Subject: Proposed Site Characterization Activities for the Cinder/Slag Fill Area Located on LPT's Yellow Parcel

This letter is in reference to the *Proposed Site Characterization Activities for the Cinder/Slag Fill Area Located on LPT's Yellow Parcel*, submitted to EPA, PADEP, and Upper Merion Township by Penn E&R on April 27, 2001 for the Crater Resources Site ("Site"). The following comments are provided on this document.

Subject: Addendum to the Site Characterization for the Cinder/Slag Fill
Area Located on LPT's 2301 Renaissance Boulevard Property

Figure 1
Map Showing Approximate
Locations At Which Soil
Borings Will Be Installed
Around and Through
The Cinder/Slag Fill Area

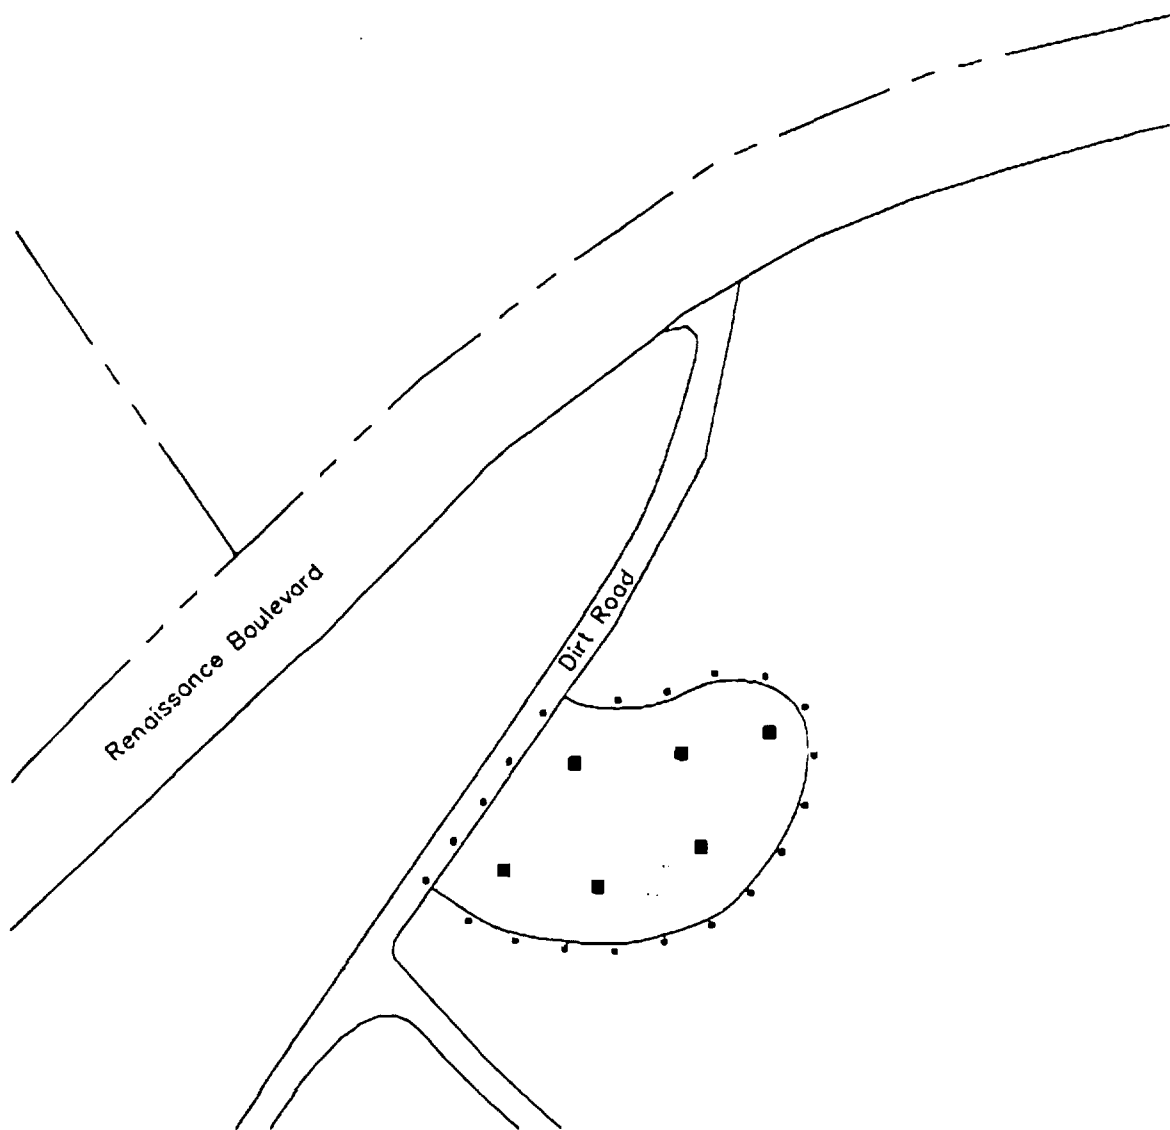
1. A map should be provided with the proposed test pit locations for both the extent investigation and the characterization sampling locations.
2. The method of test pits for the extent should be further detailed- will the pit continue completely around the perimeter until waste is encountered, or are a series of pits anticipated. If so, what is the spacing?

1. A map showing the approximate locations of the soil borings (as discussed below and suggested in EPA's April 30th letter, soil borings will be installed rather than test trenches) to be installed in and around the cinder/slag fill area is included as Figure 1.

2. A series of soil borings installed around the perimeter of the cinder/slag fill area, as shown on Figure 1, will be used to delineate the extent of the fill material. The soil borings installed around the perimeter of the area will be spaced every 50 feet. Based on current estimated dimensions of the area, about 20 borings will be installed around the perimeter of the cinder/slag fill area. If fill is encountered in any of these initial perimeter borings, another boring will be installed five feet further out away from the cinder/slag fill area. This process will be continued until the extent of the fill material has been delineated. The borings will be advanced to a depth of 10 feet or native soil, whichever is encountered first.
